File 1994-0133

Name: Grand Valley Ntl. Bank Drive-up - Rezone - RMF-32 to PB

# REVIEW COMMENTS

TITLE HEADING: Rezone from RMF-32 to PB &  
Final Plan

**LANDSCAPE PLAN**  
 1" = 20'-0"

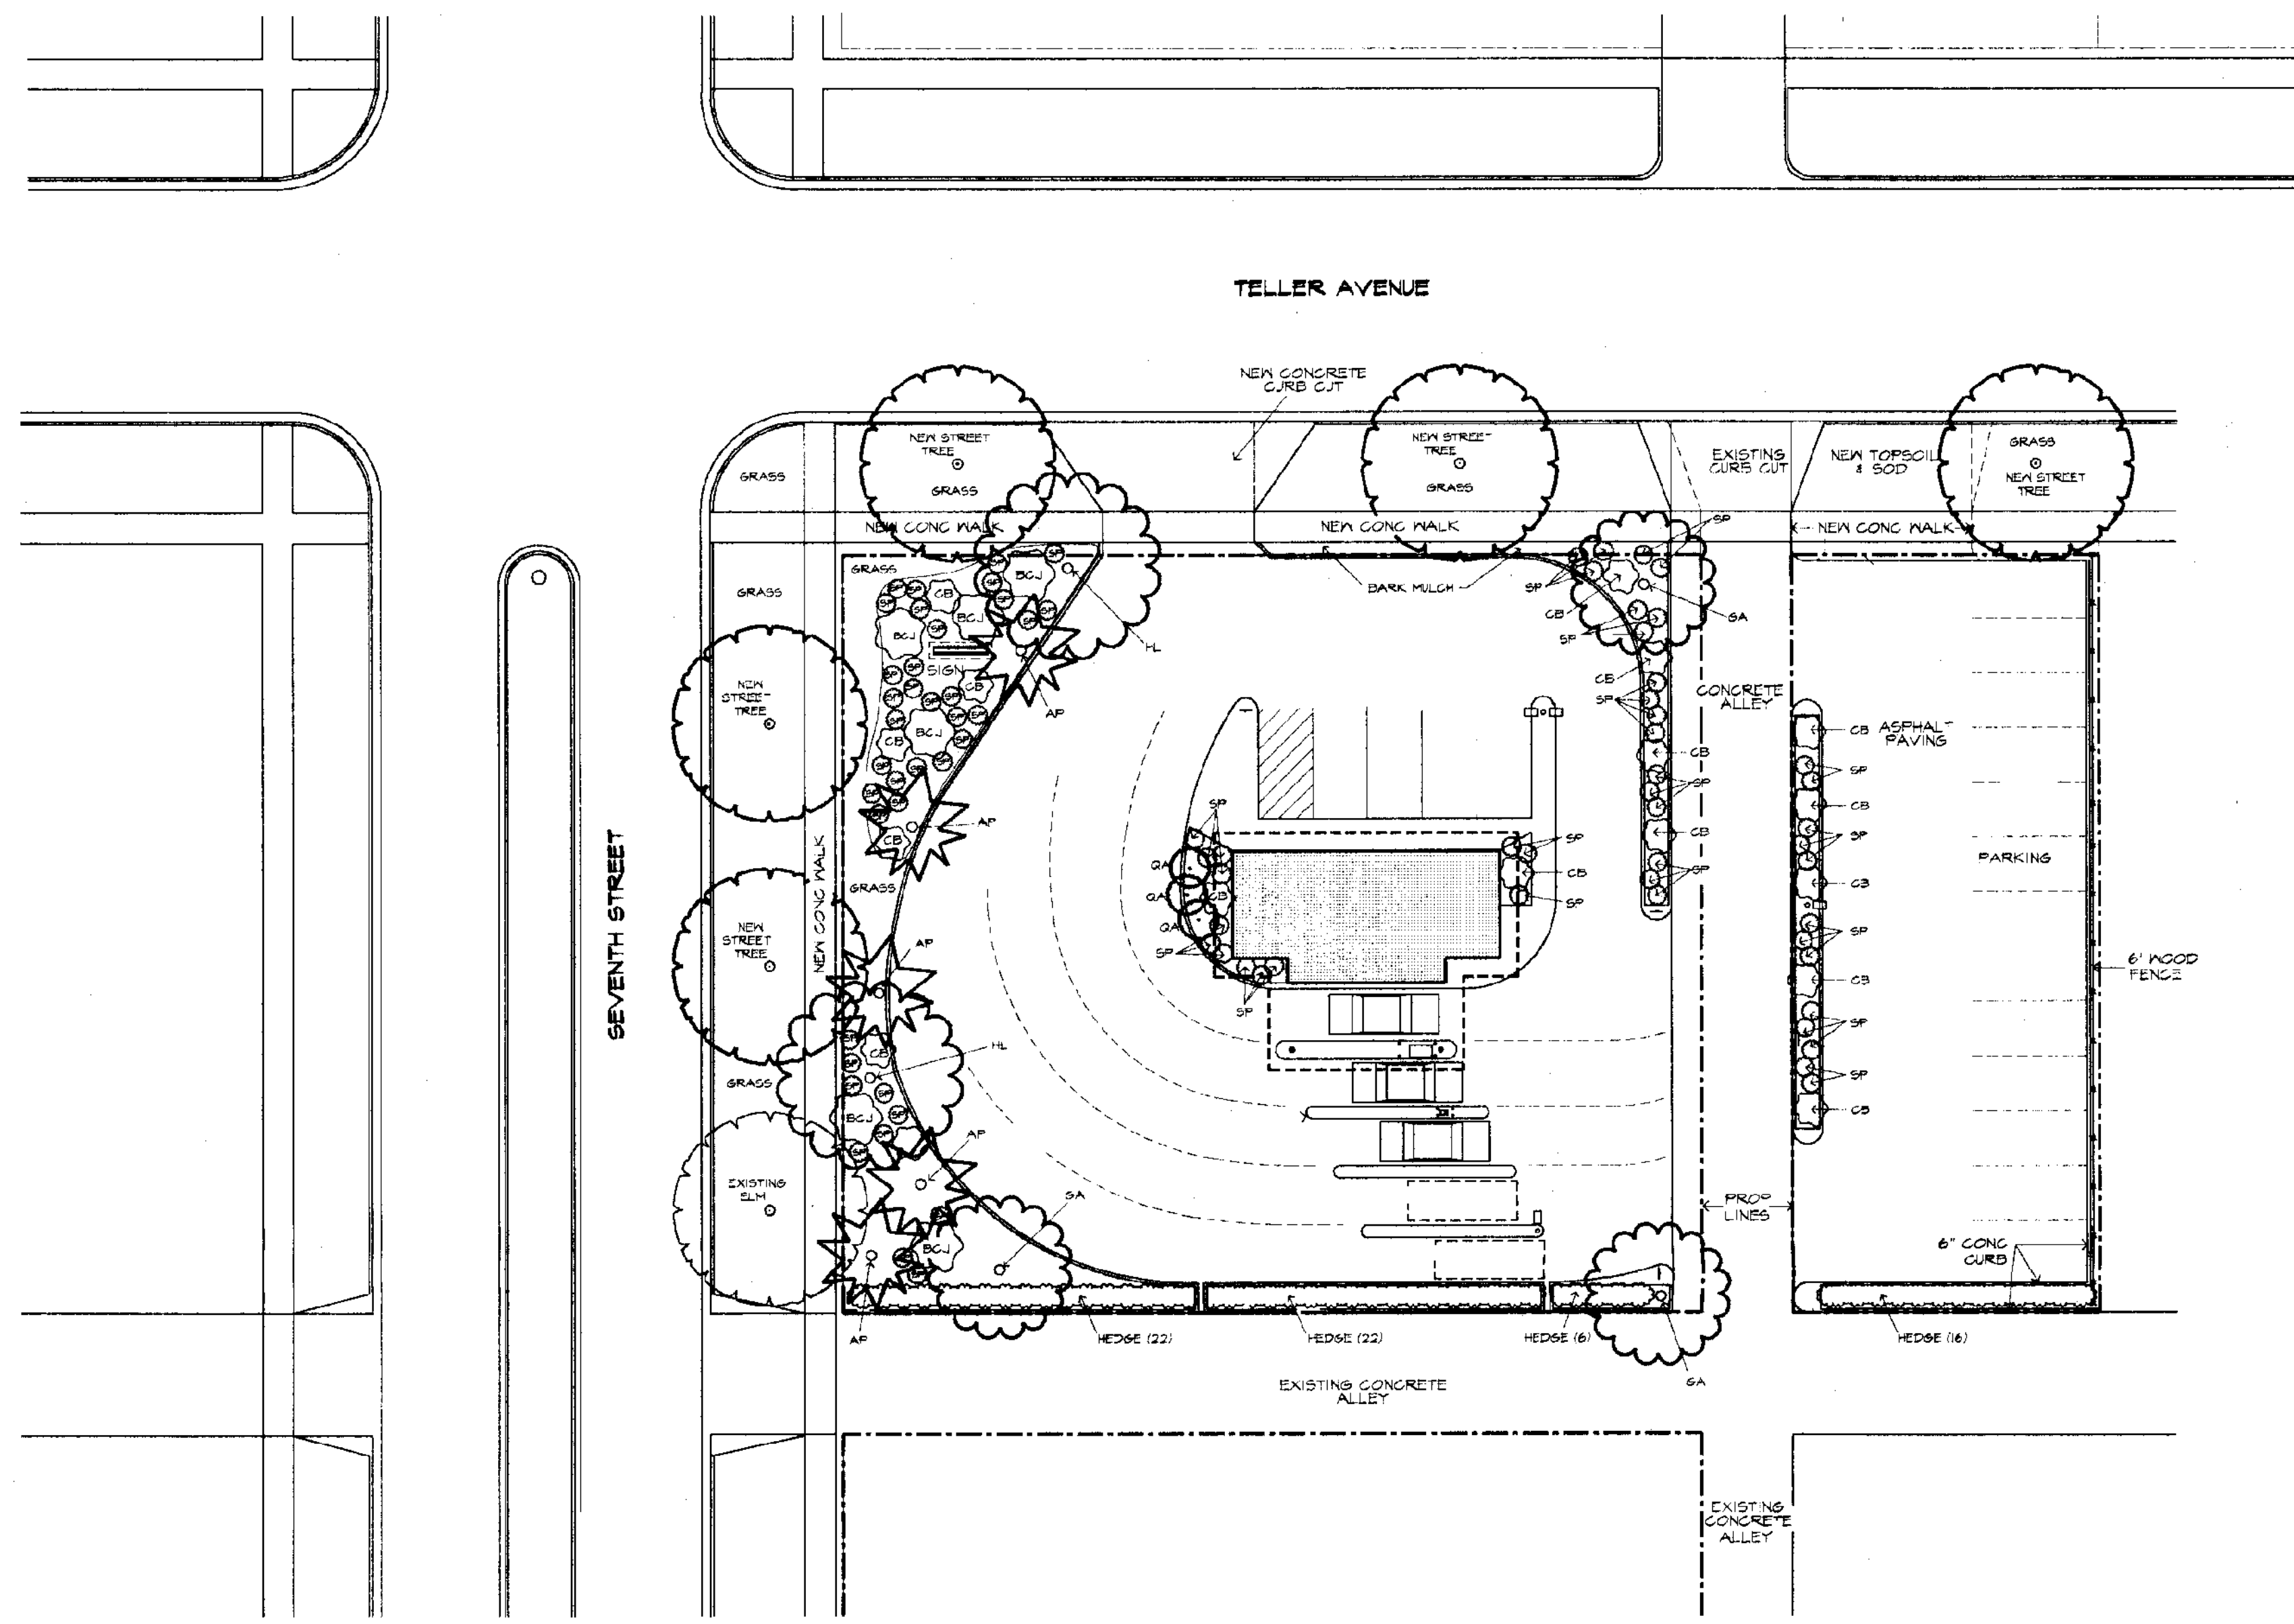
1. The landscape plan needs to comply with the SSID Manual checklist.
2. The perspective drawing shows landscaping in the parking area but none is shown on the landscaping plan.

Pg. IX-20 LANDSCAPE PLAN

A-improper scale; K-incomplete; also items 4-include common and botanical names, quantities, min. sizes as per ordinance; 7, and 8.

The perspective drawing is inconsistent with the submitted landscape plan and shall be revised to accurately depict existing and proposed vegetation.

- a. Street trees shall be provided by the applicant along 7th Street and Teller Avenue to conform with the existing streetscape. Plantings shall meet the minimum requirements as set forth in the Code.
- b. A planting bed adjacent to the proposed building would help to break up the proposed unbroken expanse of concrete and pavement.
- c. A hedge or similar group of plantings shall be provided along the fence on the south side of the parking area east of the alley.
- d. Additional planting shall be provided to better shield the proposed parking and maneuvering areas from the street.

- 1) Reference the revised Landscape Plan, Sheet A2.
- 2) A privacy hedge has been shown separating the new parking area and the east/west alley.

- 5) The building sign has been moved in accordance with City standards. Reference the revised Site Plan, Sheet A1.
- 6) Landscaping:
  - a) Street trees are shown on the revised Landscape Plan, Sheet A2. Spacing of trees and tree species and size will conform to City standards.

- b) Planting beds with low shrubs (three-foot maximum) are shown on the east and west side of the building.
  - c) A hedge is shown along the south property line of the parking area.

- d) Additional planting is shown on the property along 7th Street.
- 7) Curbed areas separating paved vehicular circulation and the north/south alley (on both sides of the alley) are shown on the revised plans. Each curbed area shall include low shrubs.

**GRADING AND DRAINAGE PLAN**  
 1" = 20'-0"

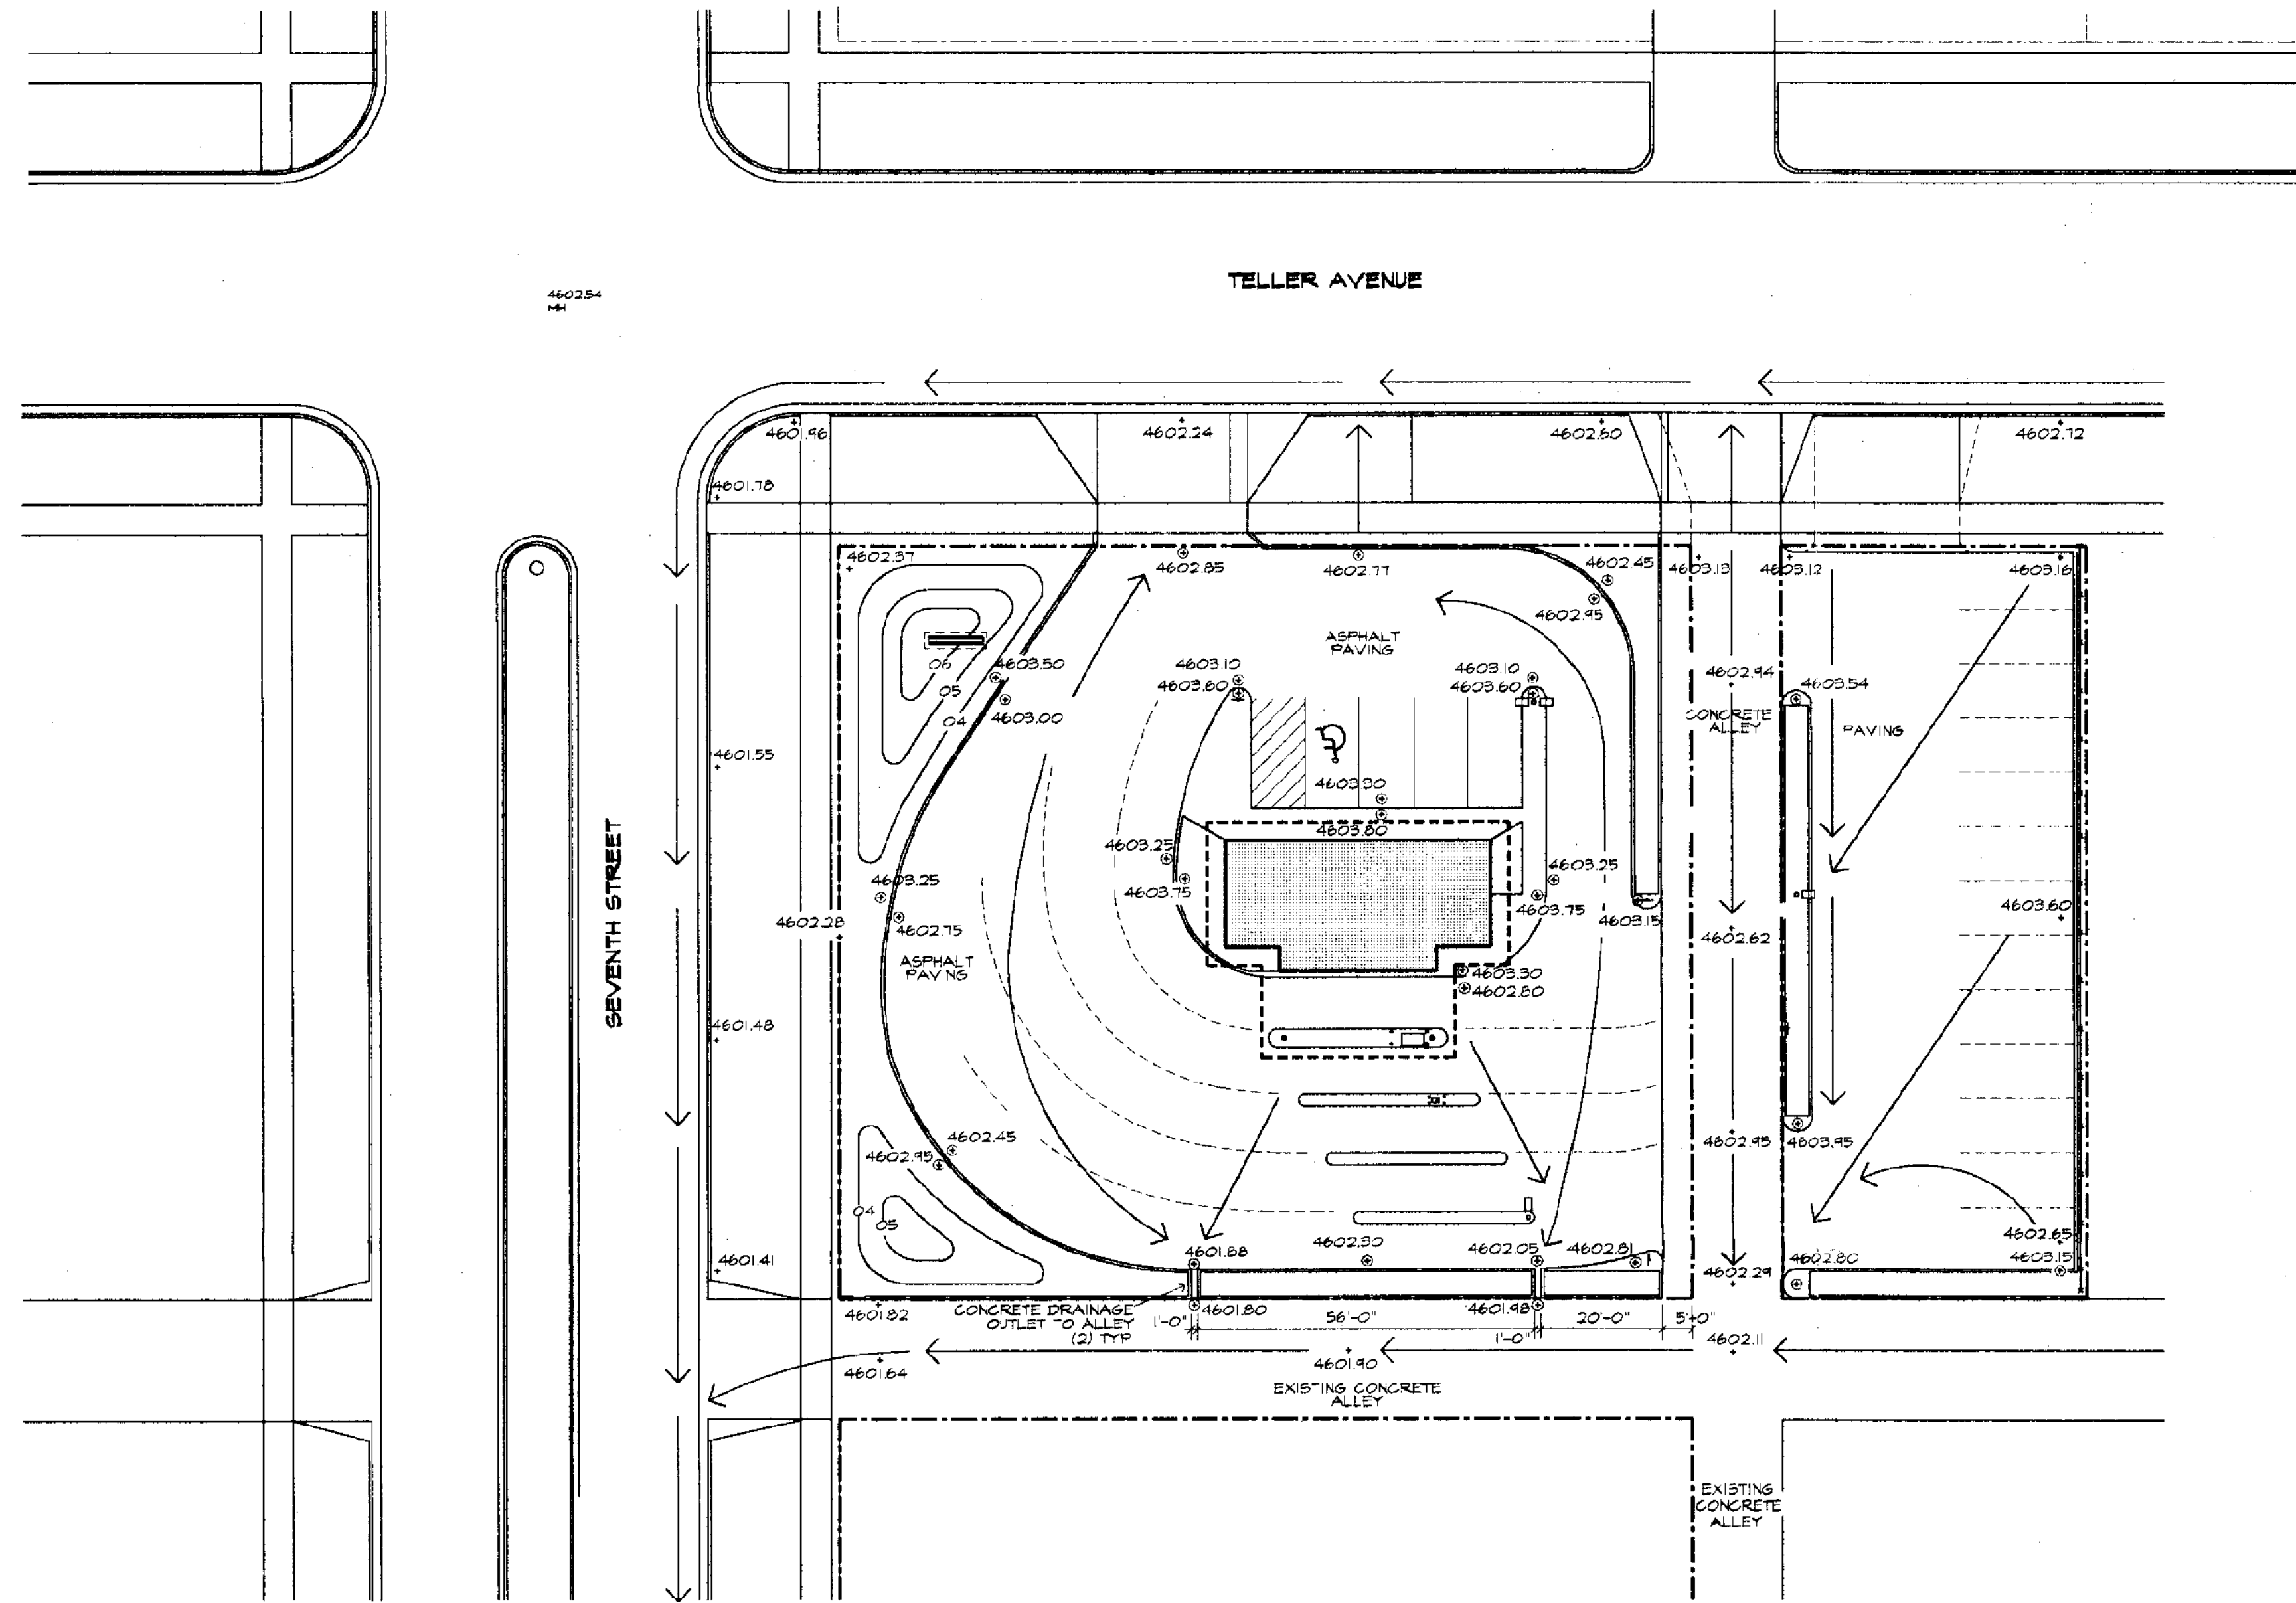
**Grading and Drainage**

1. I will need the square footage of landscaping on site to calculate the drainage fee.
2. Are the two gaps shown in the landscaping area on the south side of the site intended as curb openings? If so, please identify and dimension.
3. Again, curbing around the pavement to separate it from the landscaping and adjacent property should be shown on the plan.

- 1) Square footage of total site, with a breakdown of hard surface and landscaping is provided on the Landscape Plan, Sheet A2, and the Grading and Drainage Plan, Sheet A3.

- 2) Drain-ways through concrete curbs at the south side of the site are dimensioned on the revised Site Plan, Sheet A1.
- 3) Concrete curbs are identified and detailed on the revised Site Plan, Sheet A1.
